**Ventura Countywide  
Stormwater Quality  
Management Program**

May 27, 2008

**SUBJECT: DRAFT TENTATIVE ORDER OF THE VENTURA COUNTY MUNICIPAL SEPARATE STORM SEWER SYSTEM PERMIT (NPDES No. CAS004002) FOR THE VENTURA COUNTY WATERSHED PROTECTION DISTRICT, COUNTY OF VENTURA AND THE INCORPORATED CITIES**

Table 2.

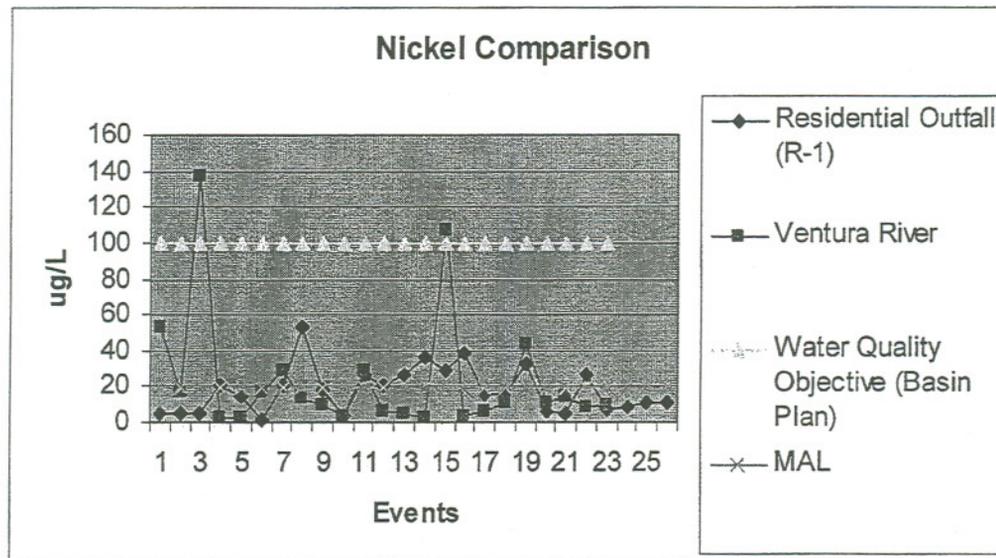
Ventura County are out of compliance with the nickel MAL (see above Table 1), but not necessarily with the applicable water quality objective. In sum, the waterbodies exceed the MALs even though they comply with the applicable water quality objective that supports beneficial uses. Consequently, the Permittees will be found to be out of compliance with the MEP standard even though they are not causing or contributing to an exceedance of an applicable water quality standard. A plot of monitoring data for the Ventura River (of which the watershed is only 3% developed) and a residential outfall as compared to the MAL, and the water quality objective is shown in Table 2 below.

A closer review of Table 2 shows the Ventura River is substantially in compliance with the water quality objective in the Basin Plan but not the MAL. Furthermore, because the waterbody is primarily in compliance with the applicable water quality objective, discharges from residential storm drain outfalls are clearly not causing or contributing to an exceedance of a water quality standard. Thus, the MS4 discharges and the waterbody do not exceed or impact the Basin Plan water quality standards, but due to the application of the MAL, the Permittees would be out of compliance with the Draft Tentative Order and would potentially be subject to mandatory minimum penalties for failing to comply with an effluent limitation.

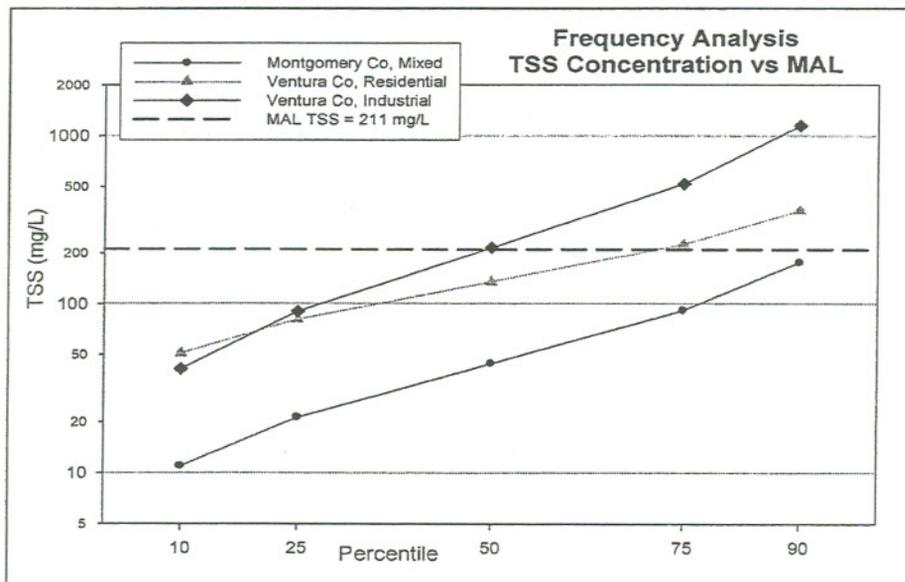
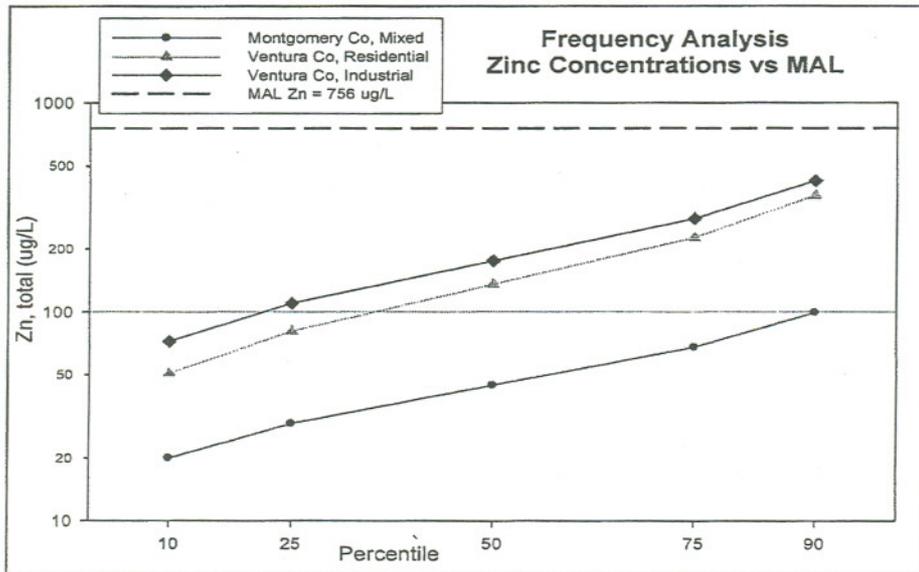
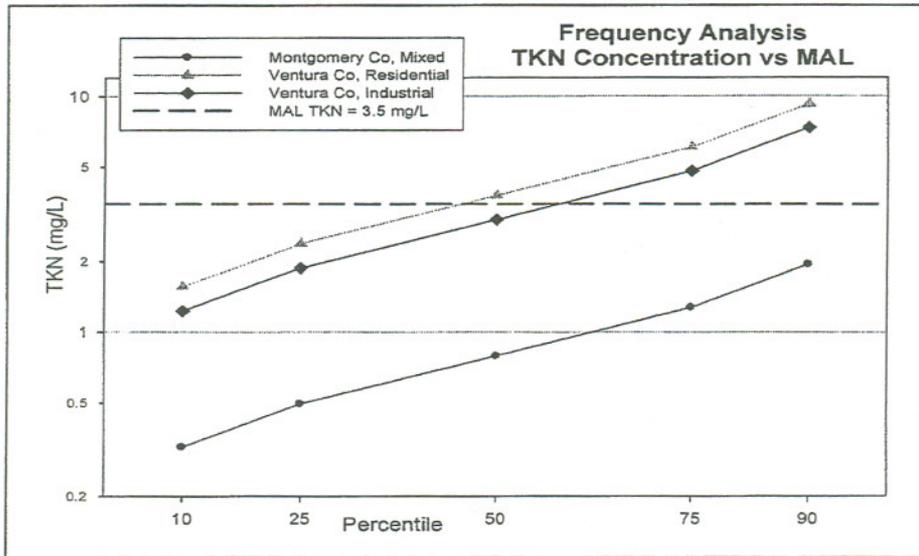
Both programs have long-term monitoring programs including characterization of discharges. A side-by-side comparison of the monitoring results of selected constituents common to both programs is shown in the following frequency distribution graphs. The proposed MALs are also included in the graphs.

A review of the graphs clearly shows that the runoff from the Montgomery area is of better quality than the runoff from Ventura County. The reason for this difference is not due to a difference in stormwater management program implementation but rather to the difference in annual precipitation. Both programs have similar implementation efforts and the outfalls examined in each program are similar in characteristics. The year-round distribution of rainfall on the east coast mitigates the build-up and wash-off of pollutants. This may be shown another way by calculating the differences in the runoff means and comparing that difference with the inverse difference in rainfall; in other words, the pollutant concentration is inversely related to the amount of rainfall.
